Office Action Summary

10/709,681

BORREGO BEL ET AL.

DETAILED ACTION

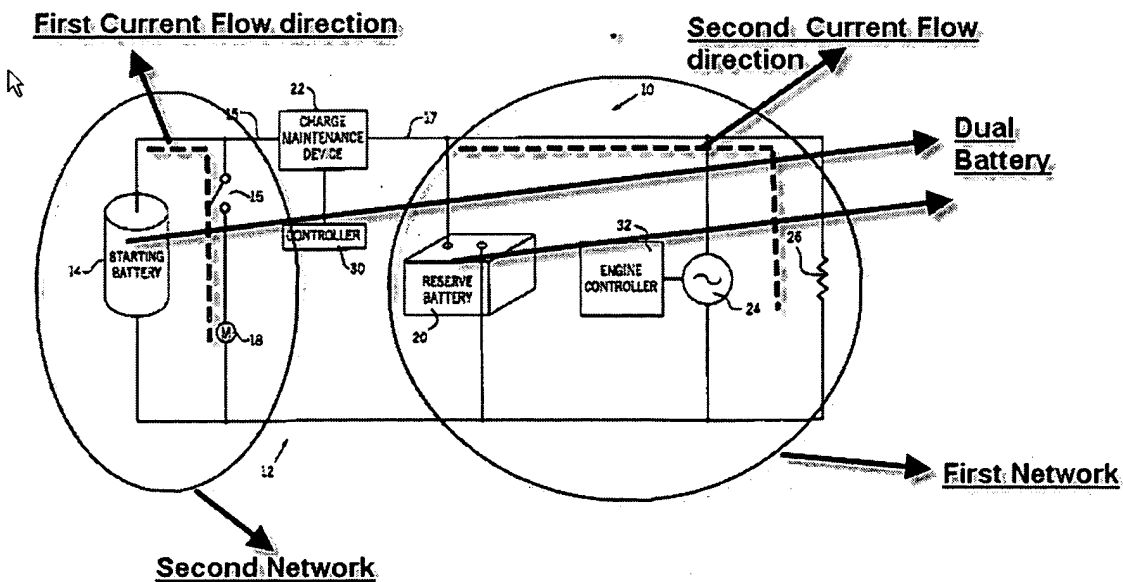
Dougherty et. al. disclose in Figures 1 and 2, a dual electrical network, a dual current flow direction and a dual battery. See figure below and also see paragraph 2, above on page 2.

Applicant also argues that references do not teach "bidirectional current flow". The claims do not have this limitation. Assuming, the applicant meant to refer "any direction" as in Claim 1. The flow of current to the load due to the reserve battery (20), and the flow of current to the element 18 due to the starting battery (14) meet the limitation (see figure above).
